GENERAL NOTES

PROJECT NAME:	CRAFTSBURY	PLOT DATE:	05-JUN-2009
PROJECT NUMBER:	BRO 1449 (24)	DRAWN BY:	W. LAMMER
FILE NAME:	96J310\str\sj310gen.dgn	CHECKED BY:	T. LACKEY
PROJECT LEADER:	R. WHITCOMB	SHEET	3 OF 47
DESIGNED BY:	W. LAMMER

LAYOUT SHEET

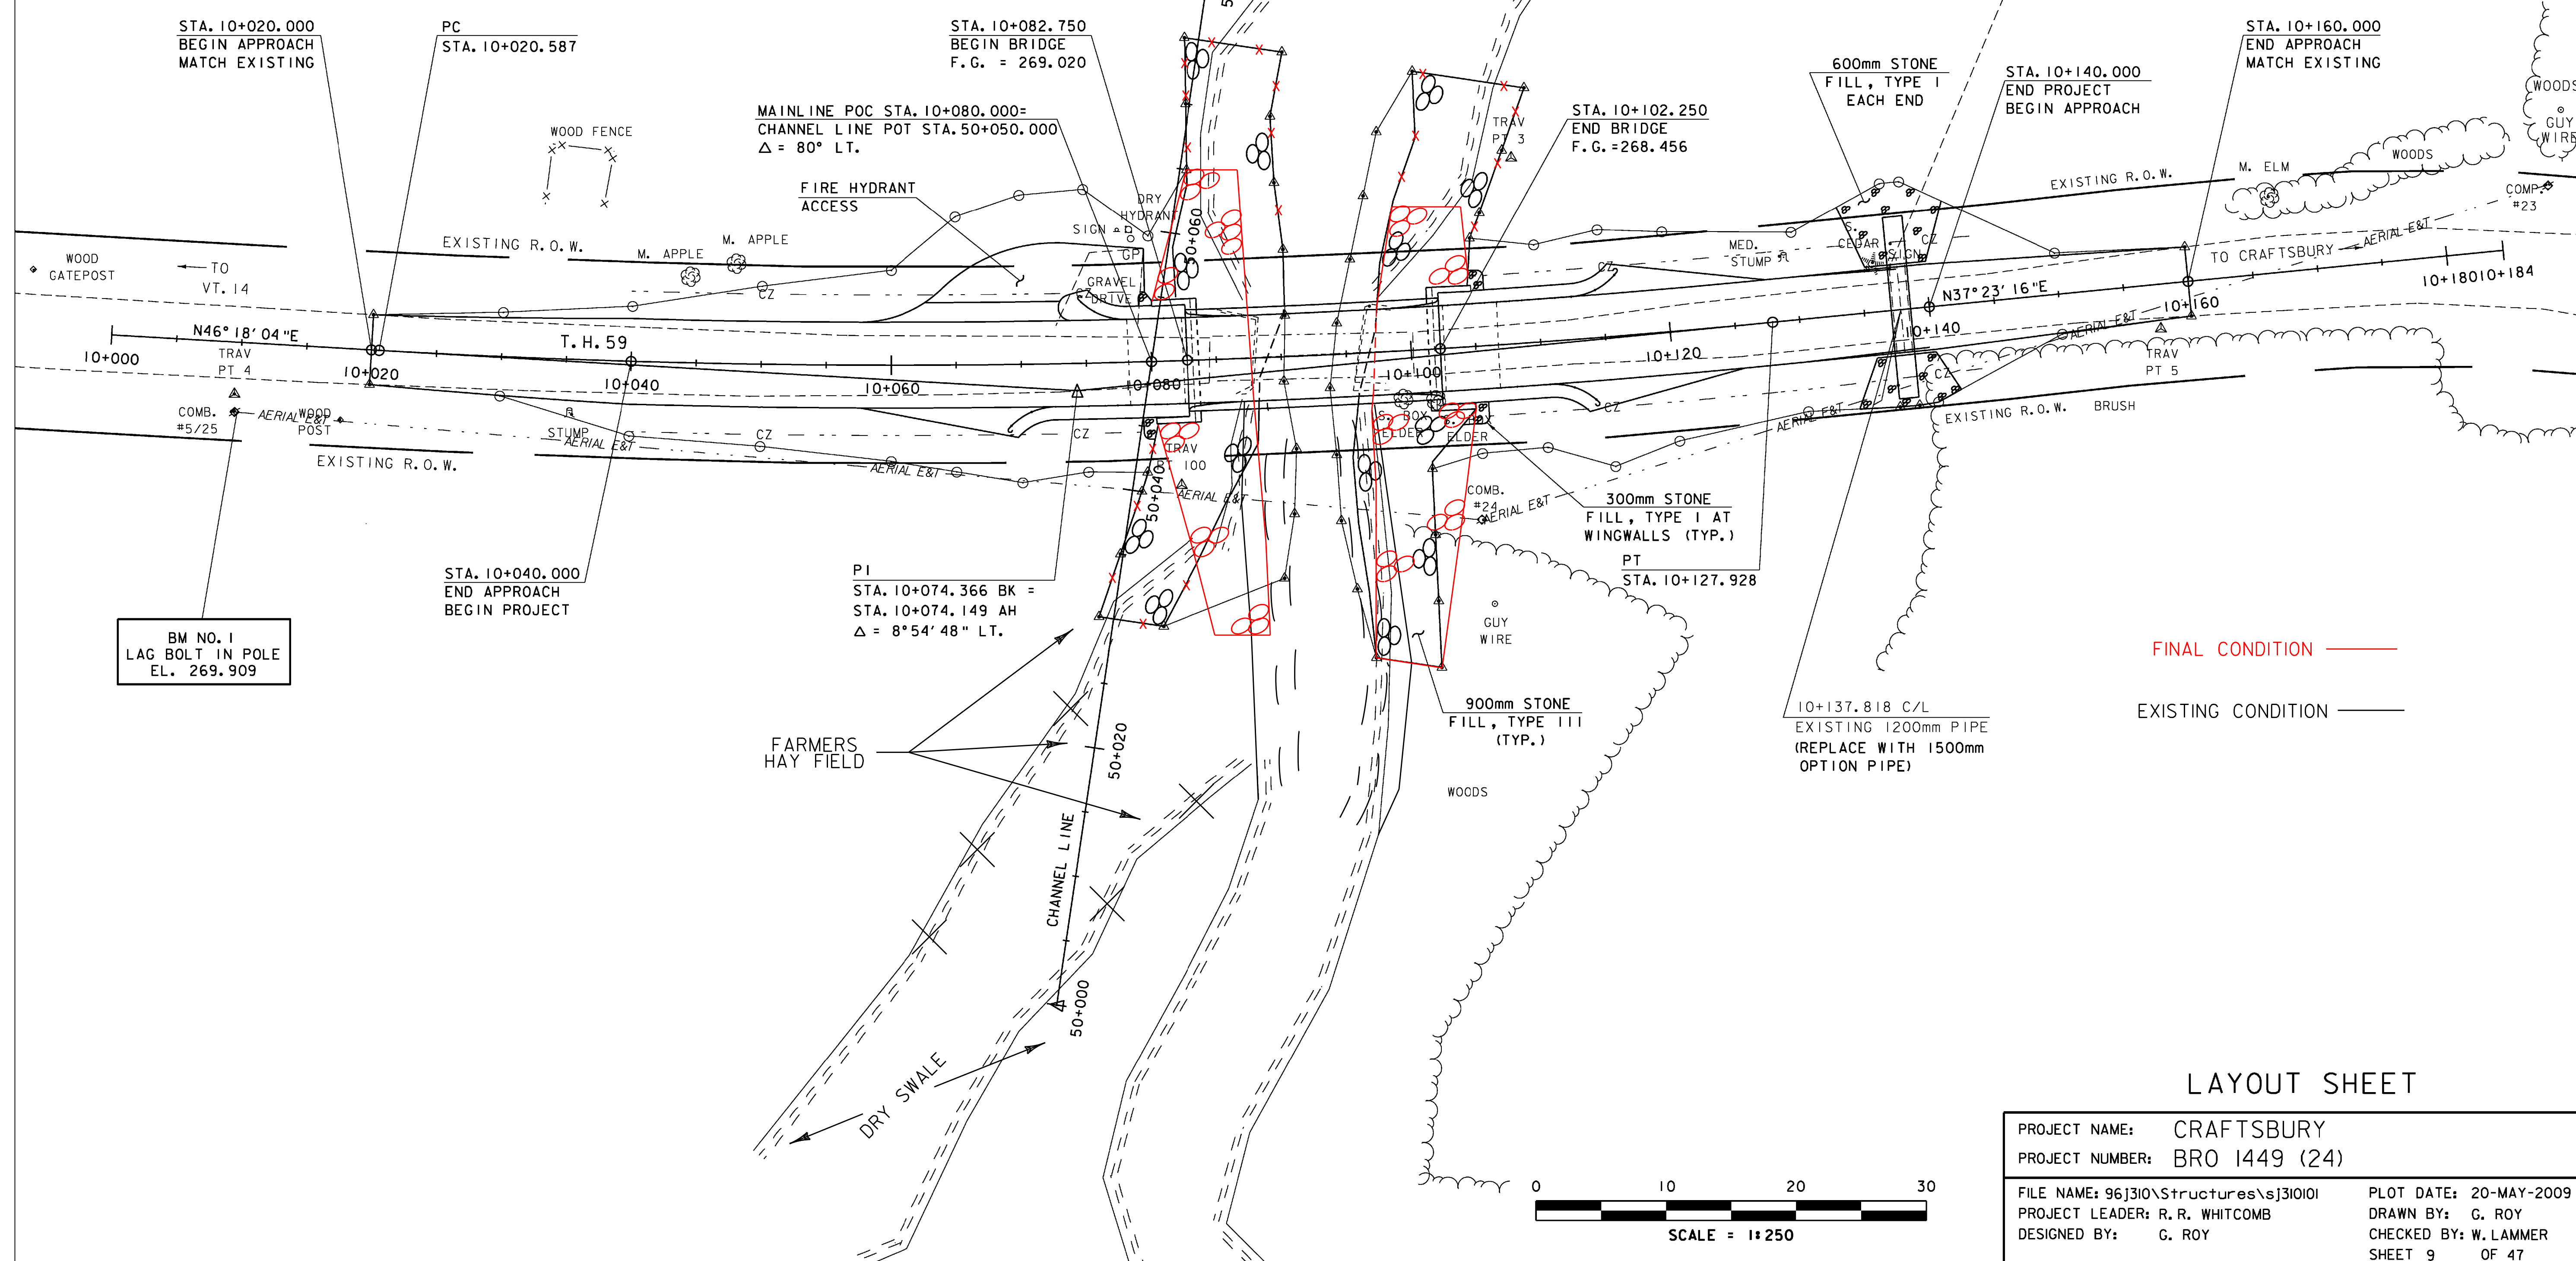
FINAL CONDITION ———
 EXISTING CONDITION ———

MAINLINE PROFILE

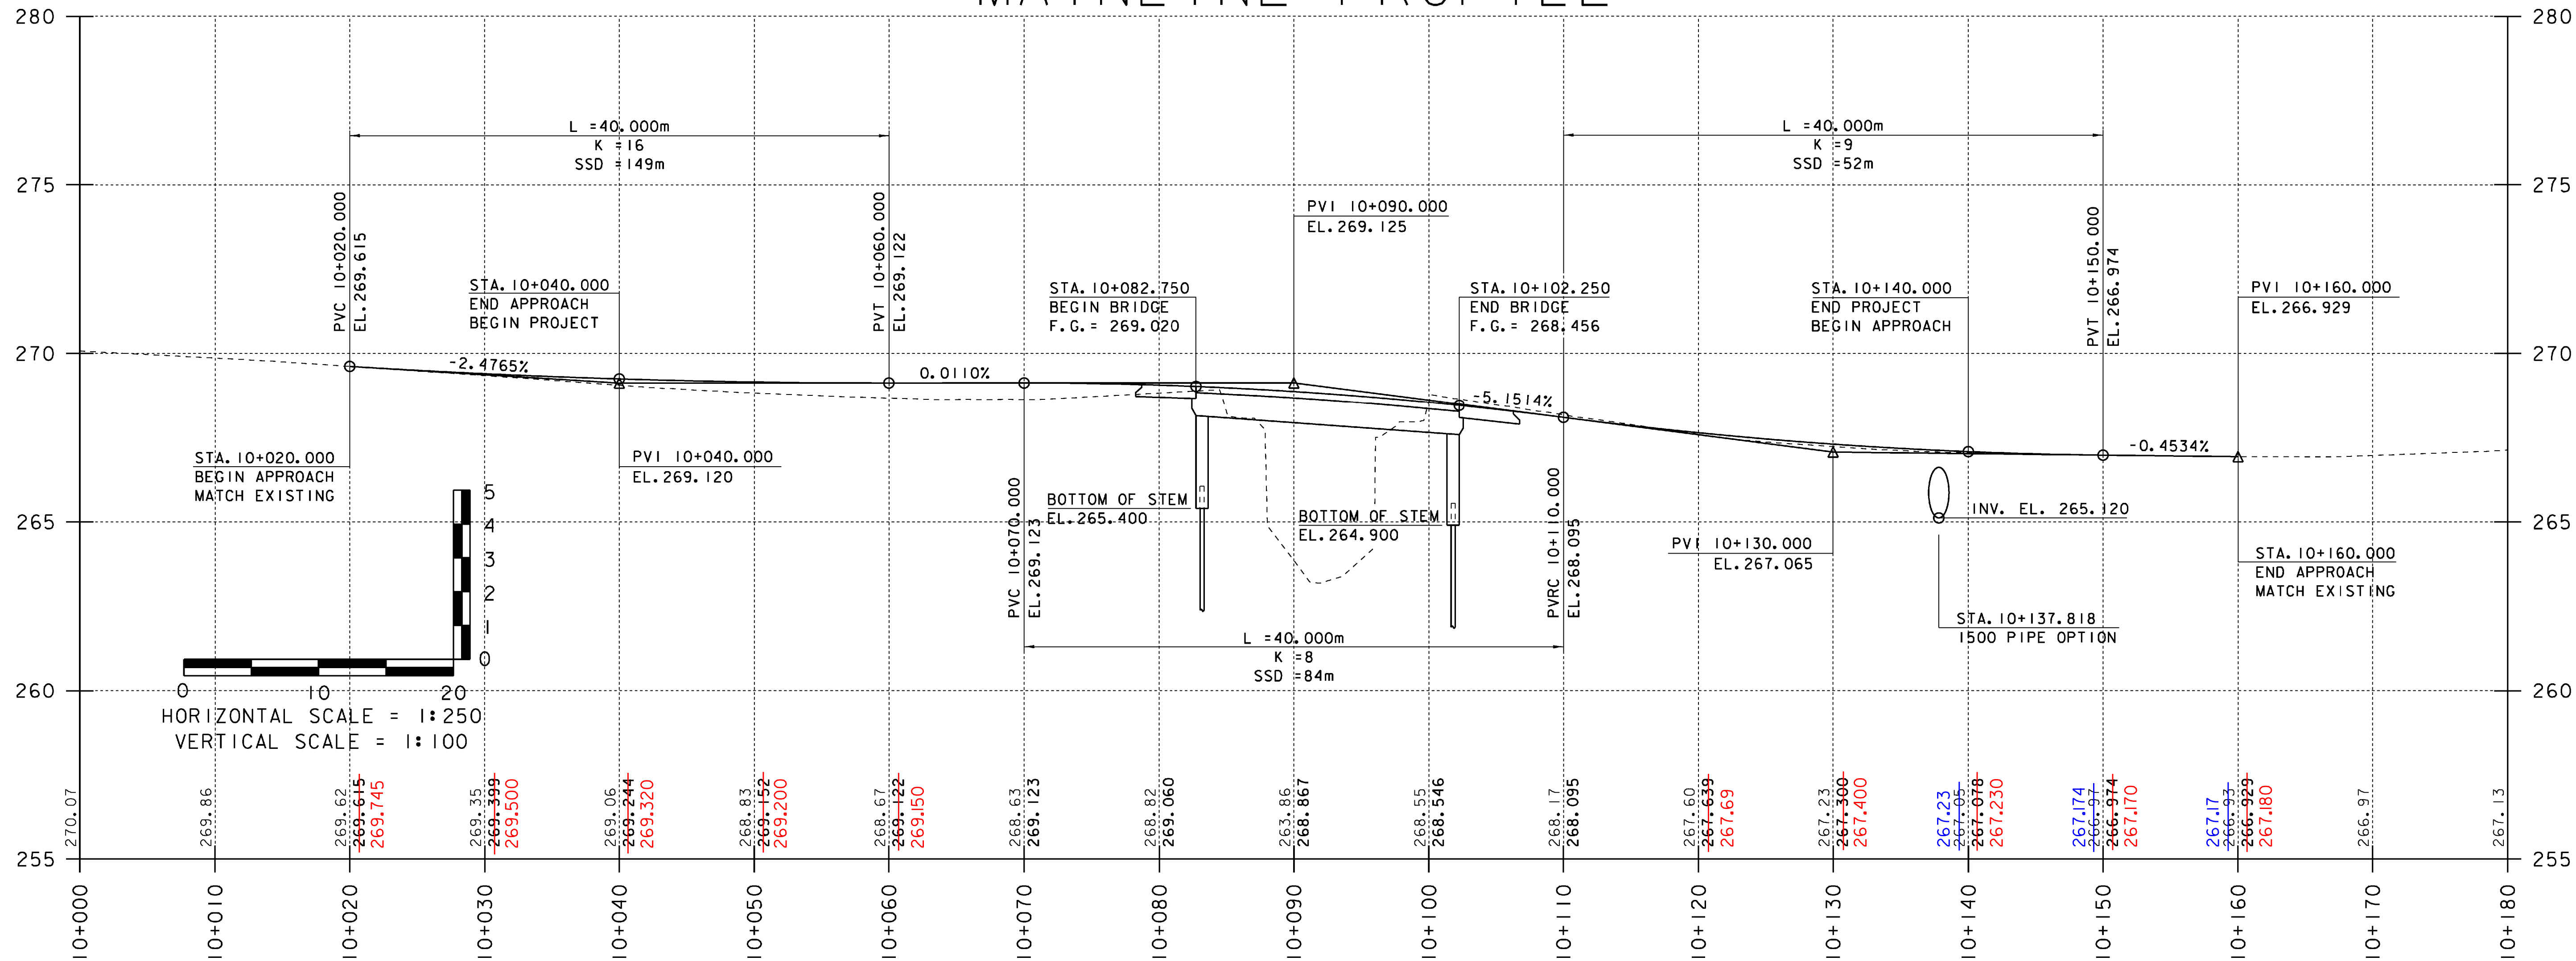
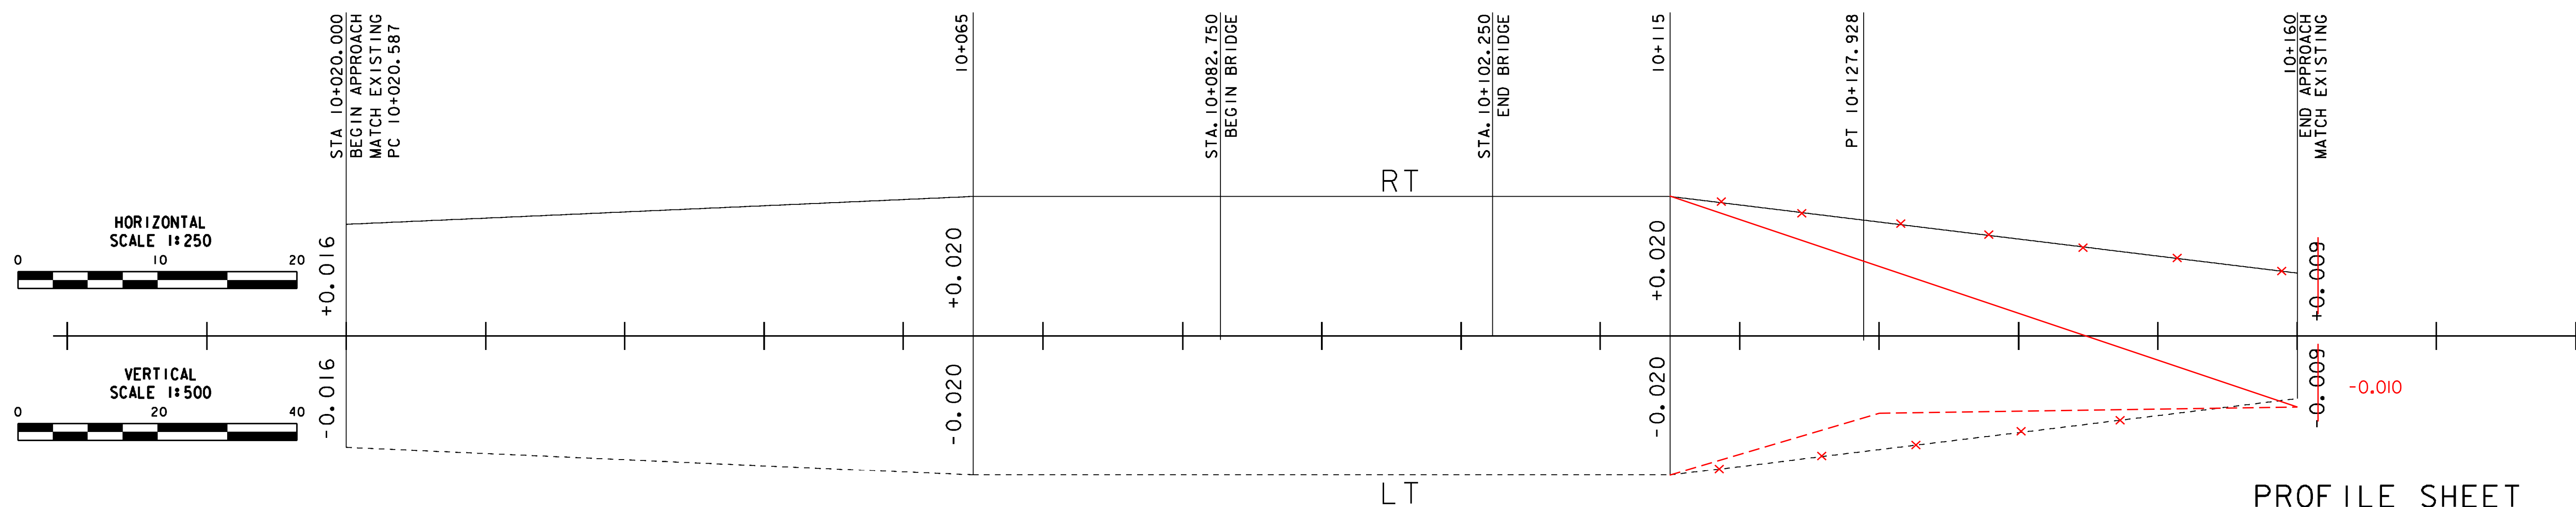
BOTH ENDS OF THE PROJECT WERE DESIGNED LOW. GRADES WERE "RE-WORKED" TO MATCH THE EXISTING ROAD.
